# Chapter 25 Small Wastewater Systems Revisions

Wyoming Department of Environmental Quality  
Water Quality Division  
Principal Regulation Engineer  
Frank A Strong IV, P.E.

## Section 2 – Objective – Comment revisions

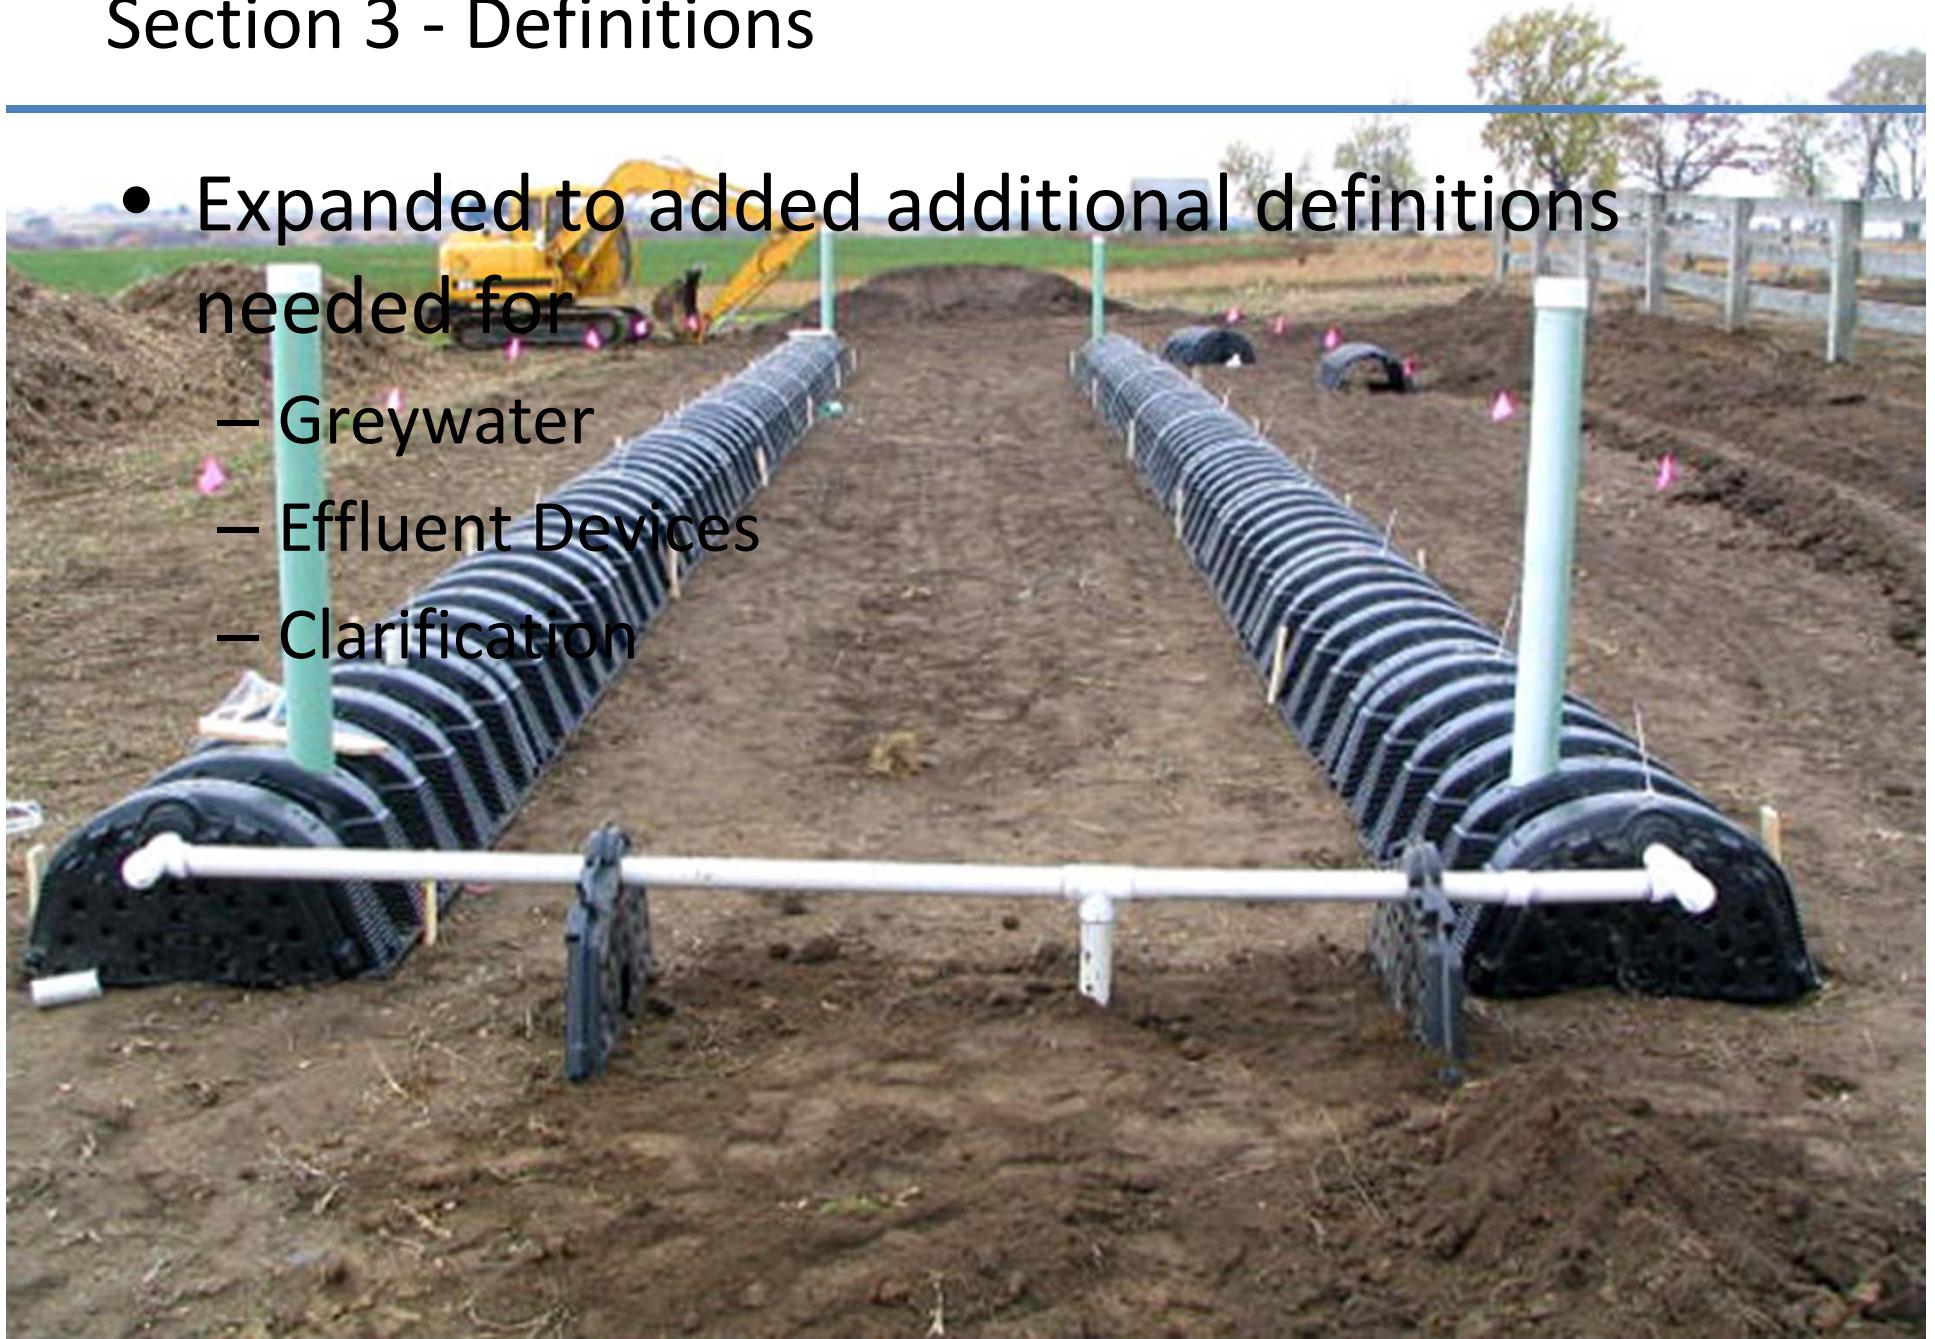
- Revised for 2000 gallons or less and removed average as defined in statute. (line 14)
- Advance system removed (Line 18)
- P.E. required for non-domestic wastewater from commercial and industrial facilities. (Lines 16 – 20)
- Inserted final paragraph requiring permits be obtained (Line 22)

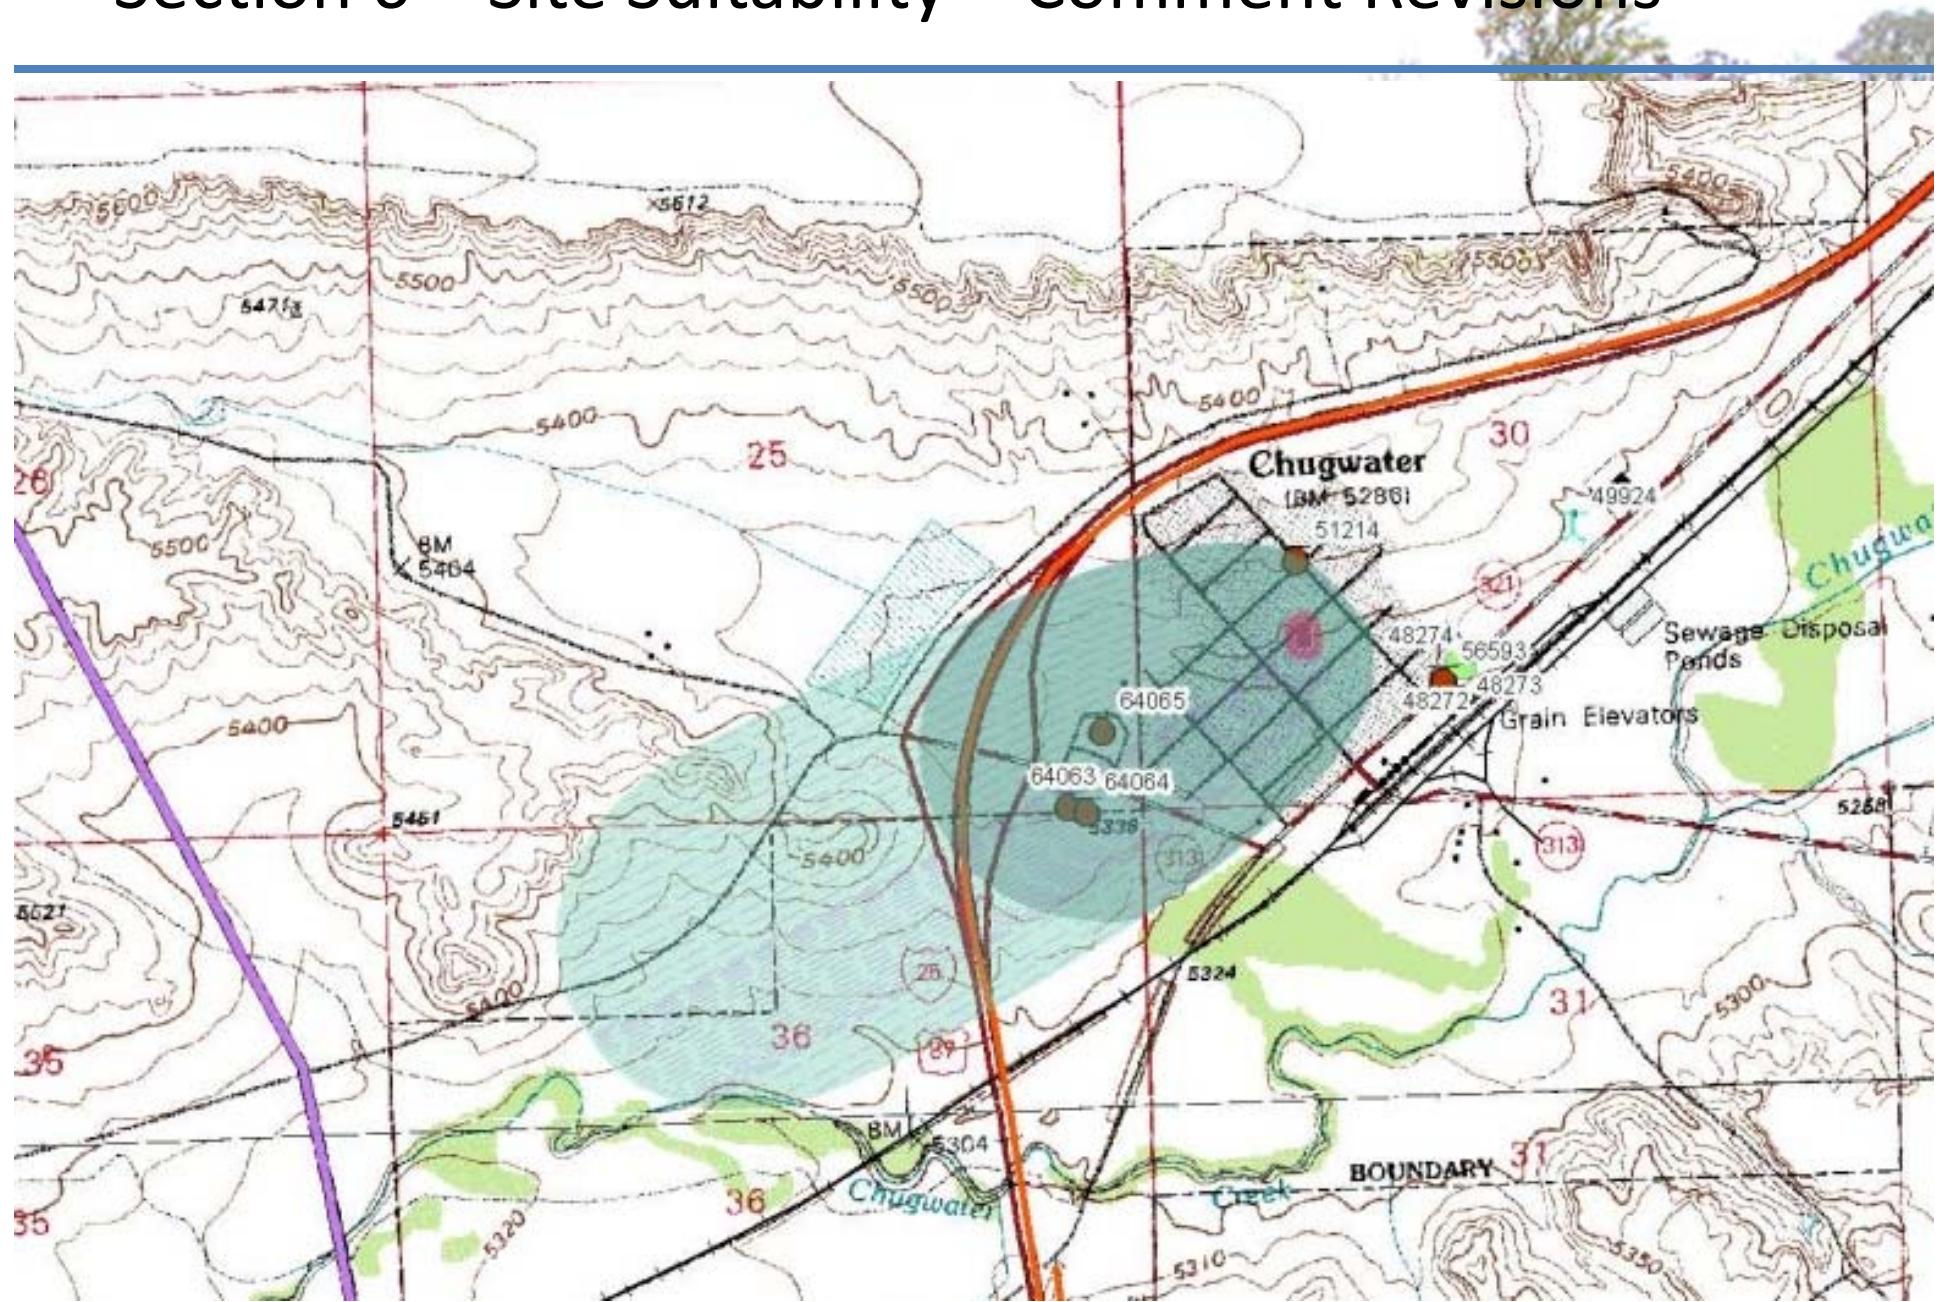
- Added fractured rock to vertically separation (Line 251)
- Clarified public water supply well in the table (Line 359)
- Removed 600/300 feet setback (Line 359)
- Additional treatment required within Zone 2 of a public water supply well (Line 364)

## Section 7 – Drain Field Sizing

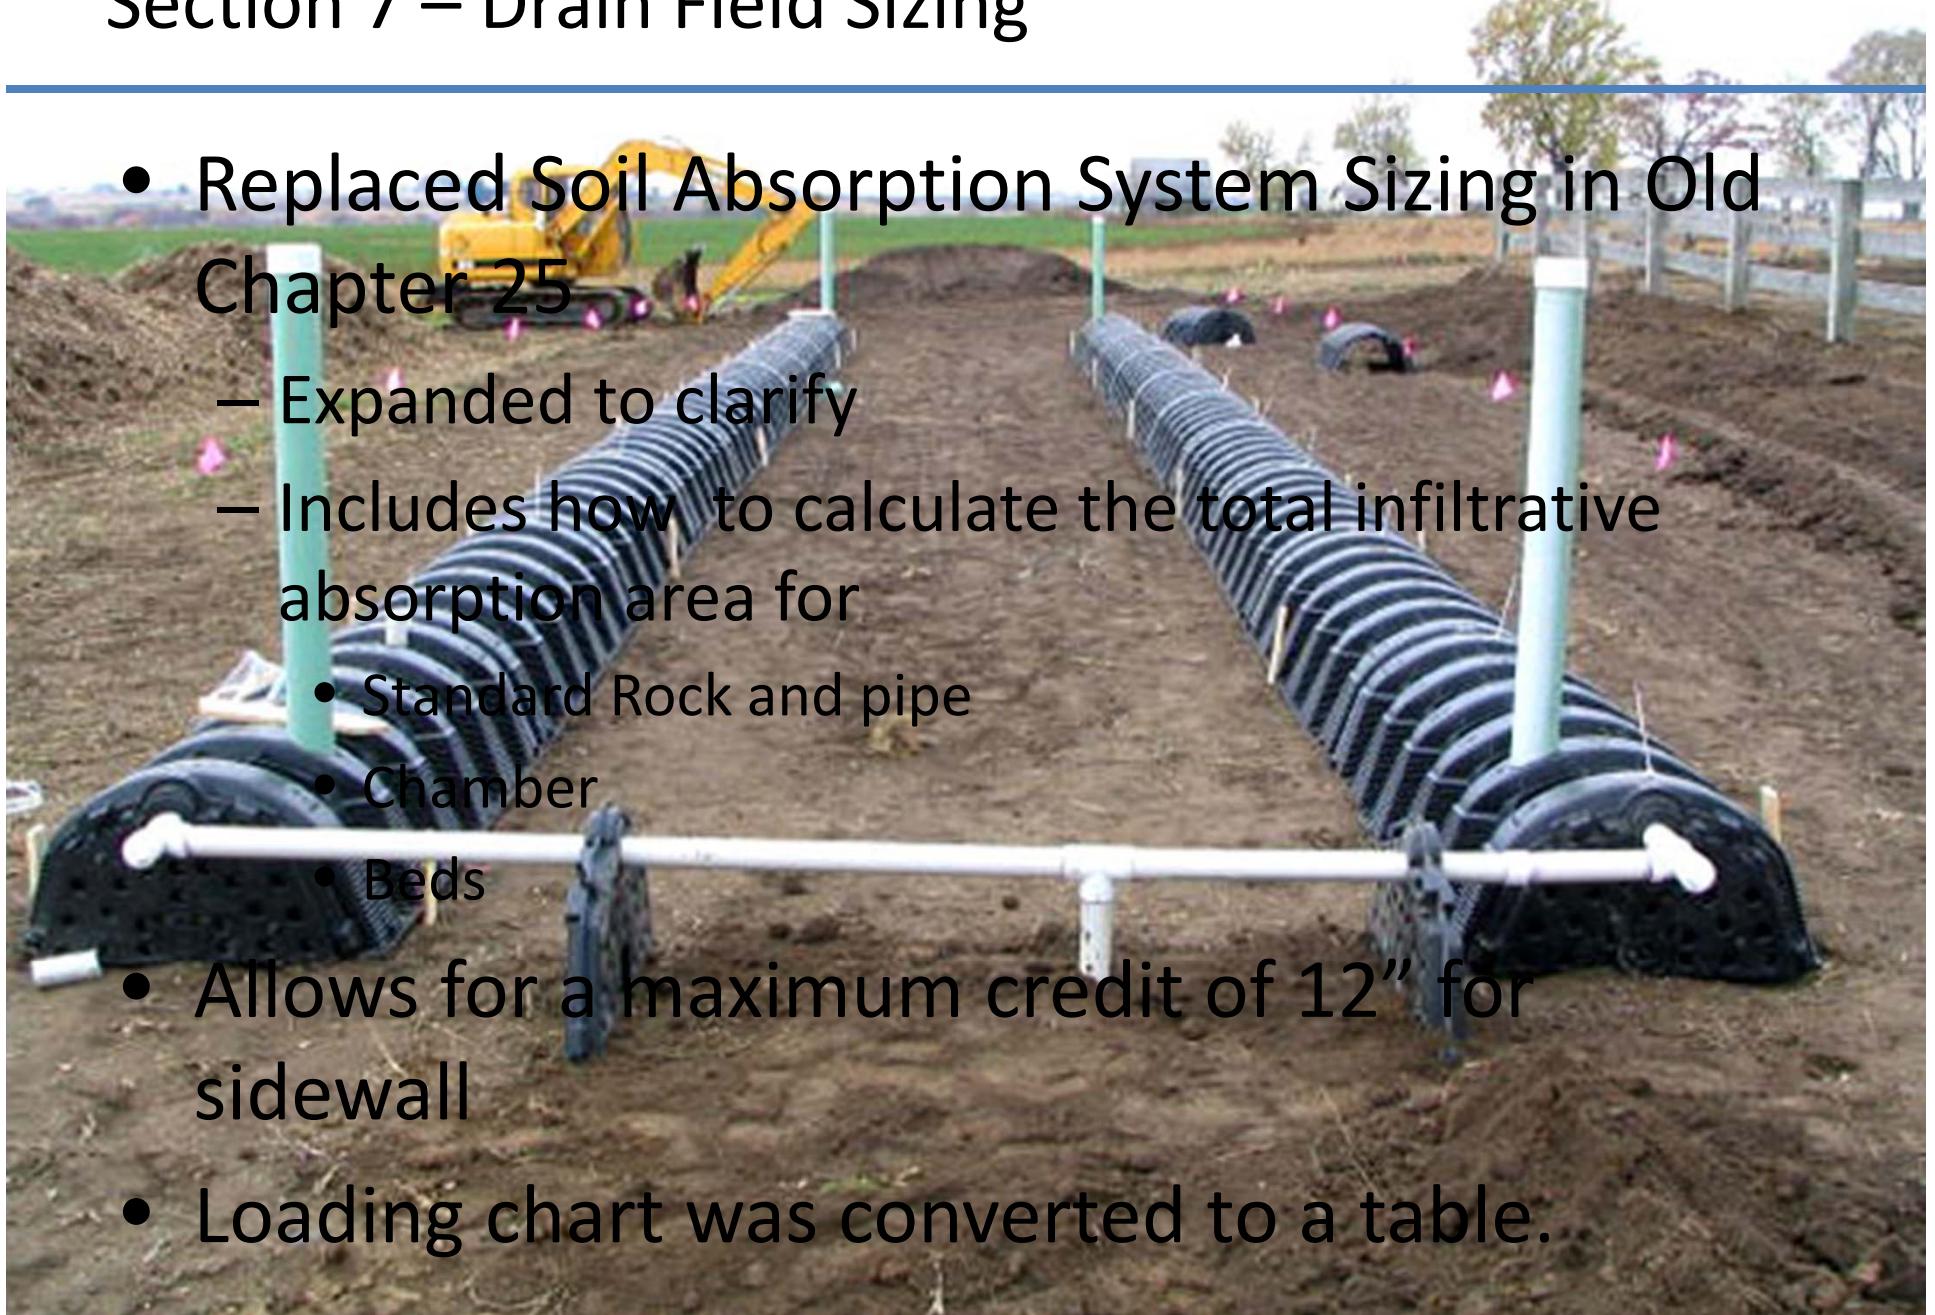
- Replaced Soil Absorption System Sizing in Old Chapter 25
  - Expanded to clarify
  - Includes how to calculate the total infiltrative absorption area for
    - Standard Rock and pipe
    - Chamber
    - Beds
- Allows for a maximum credit of 12" for sidewall
- Loading chart was converted to a table.

- Provide bottom area reduction of 30% for chambers (Line 393)

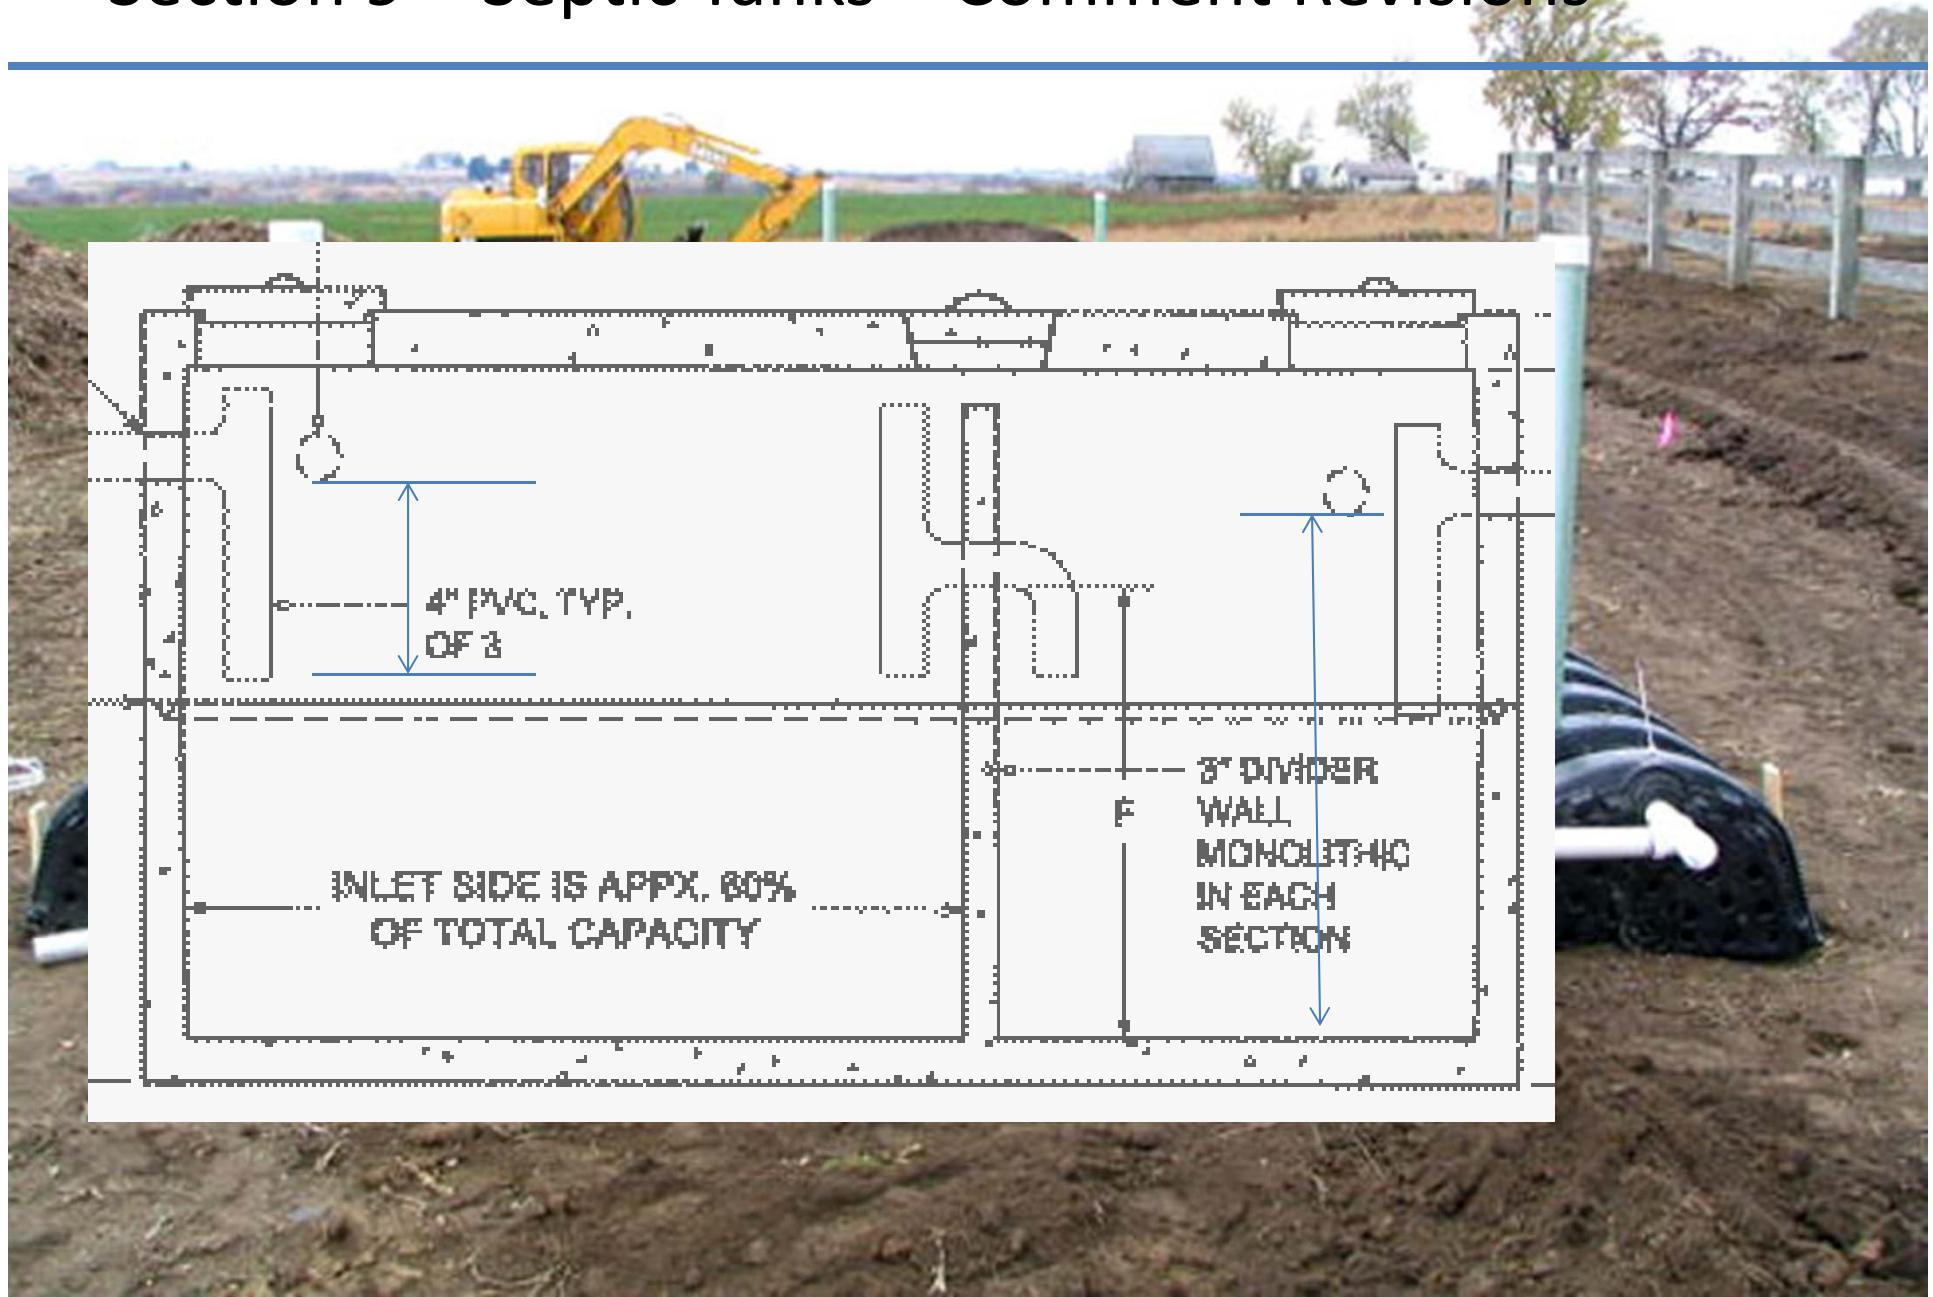
- Septic tank sized revised to provide 48 hour retention (Line 474)
- Liquid depth requirements were clarified to apply to both single and multiple compartment tanks (Line 489)
- Depth requirements for baffles or tees was revised (Line 502)

## Section 10 – Effluent Distribution Devices

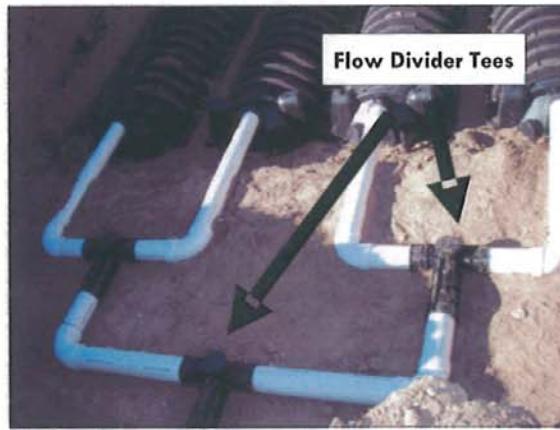
- Only distribution boxes and flow divider tees will be allowed.
- Straight tees will no longer be allowed
